**CITY OF TEMPE
HISTORIC PRESERVATION COMMISSION**

**Meeting Date: 04/14/2021
Agenda Item: 3**

ACTION: Request for a certificate of appropriateness approving proposed alterations to the Hayden Flour Mill for ORNAMENTAL IRON FENCING INSTALLATION, located at 119 South Mill Avenue. The applicant is Charlie Bladine, of the City of Tempe.

Attachment B

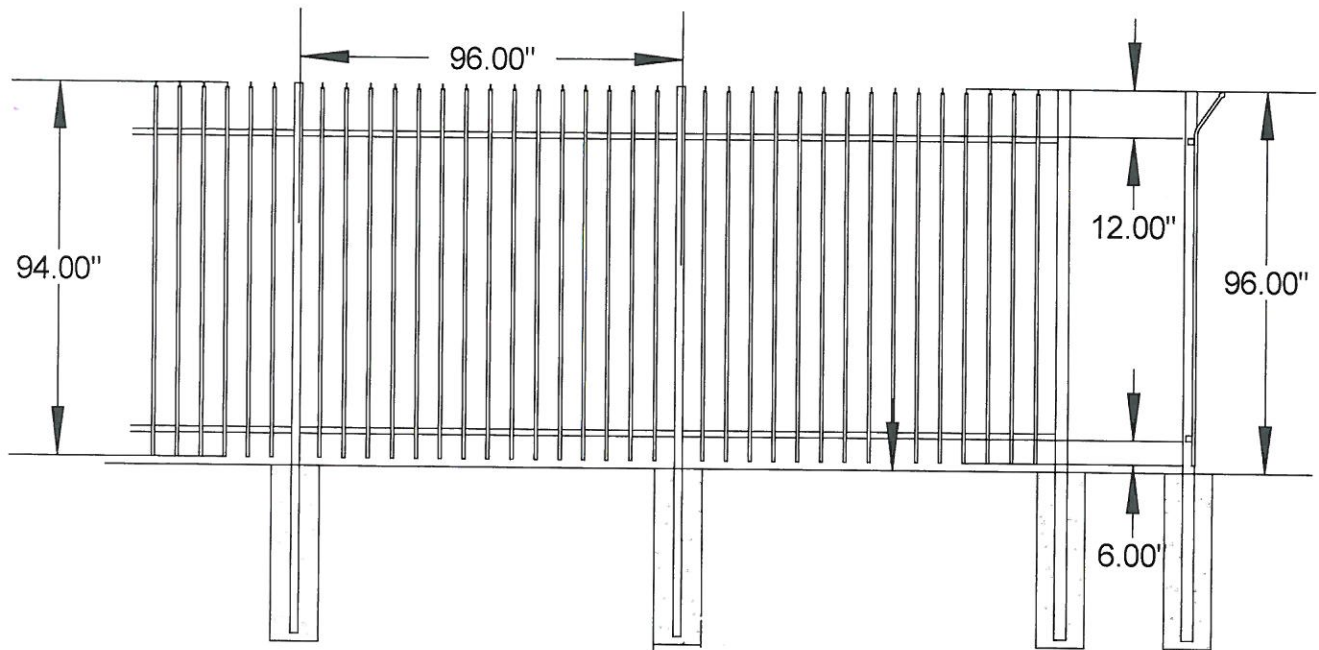
This project will replace the existing chain link fence with an ornamental iron fence. It is believed that the ornamental iron fence will serve as a more effective security measure than the existing chain link fence, which has been compromised numerous times. The proposed ornamental iron fence will not obscure the view of the mill and silos to a greater degree than the existing chain link fence.

In addition to being listed in the Tempe Historic Property Register, the Hayden Flour Mill has been determined eligible for listing in the National Register of Historic Places. The entirety of the project site sits within AZ U:9:165(ASM), a large and significant multicomponent archaeological site. Ground disturbance on municipal lands within an archaeological site requires an Arizona Antiquities Act permit. However, the project area has been extensively archaeologically mitigated. Further, it is anticipated that the replacement fencing will require fewer footings than the existing chain link fence and be installed in a manner that utilizes existing footing holes. As such, archaeological monitoring is not believed to be necessary.

- Should it be determined that ground disturbance in areas not previously subjected to data testing, data recovery, or monitoring is necessary to complete this project, an archaeologist working under a project-specific Arizona Antiquities Act permit shall be on hand to monitor all ground-disturbing activity in such areas.
- Any changes to the project submittal made to the Tempe Historic Preservation Office on March 22nd, 2021 and attached to this report must be reviewed and approved by the Tempe Historic Preservation Officer prior to fence installation.
